Work Order ID 125269

Item ID: D3166-1 Accept ***N900040100*** Setup Start ***NS1***
 Revision ID: Stop ***NS2***
 Item Name: Basket Hoop
 Start Date: 10/06/14 Start Qty: 6.00 ***6*** Cust Item ID:
 Required Date: 10/06/14 Req'd Qty: 6.00 ***6*** Customer:
 Reference:

DESIGN #	DRAWN BY CP	DART AEROSPACE LTD HAWKESBURY, ONTARIO, CANADA	
CHECKED #	APPROVED #	DRAWING NO. D3166	REV. A SHEET 1 OF 1
DATE 02.07.10		TITLE BASKET HOOP	SCALE NTS
A	02.07.10	NEW ISSUE	
A1	04.04.08	38+/- WAS 36.0

DRAWING NO. D3166	TITLE BASKET HOOP	REV A1	DART AEROSPACE LTD ENGINEERING ORDER		D.E.O. NO. D3166-A-2	SHEET NO. 1 OF 1	SCALE NTS
DRAWN AJS	CHECKED J	MFG. APPR. M	APPROVED MP		DE APPR. H		
DATE 08.12.11	DATE 08.12.15	DATE 08/12/15	DATE 08/12/16		DATE 08.12.16

D3166-1 BASKET HOOP

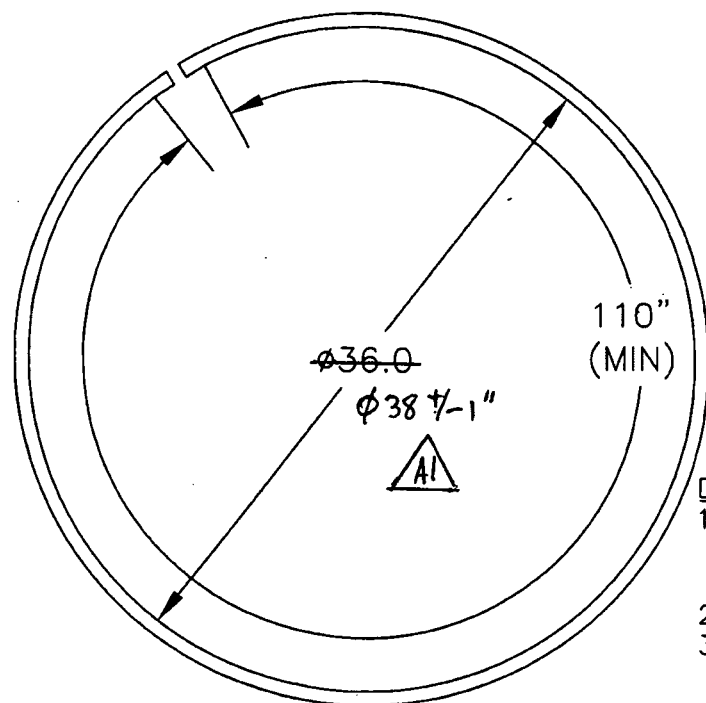
1) MODIFY MATERIAL NOTE FOR D3166-1 AS SHOWN:

WAS:

1) MATERIAL: AISI 304/316 SS SQUARE TUBING,
0.75" x 0.75" x 0.063 WALL, 60.00" LONG
(REF DART SPEC. M304TS0.750W.063)

2) MODIFY MATERIAL NOTE FOR D3166-3 AS SHOWN:

WAS:

1) MATERIAL: AISI 304/316 SS SQUARE TUBING,
0.75" x 0.75" x 0.063 WALL, 120.00" LONG
(REF DART SPEC. M304TS0.750W.063)

IS:

1) MATERIAL: AISI 304/316 SS, 3/4 X 3/4 X 0.065 WALL SQUARE TUBING,
60.00" LONG
REF. DART SPEC M304TS0.750W.065

IS:

1) MATERIAL: AISI 304/316 SS, 3/4 X 3/4 X 0.065 WALL SQUARE TUBING,
120.00" LONG
REF. DART SPEC M304TS0.750W.065
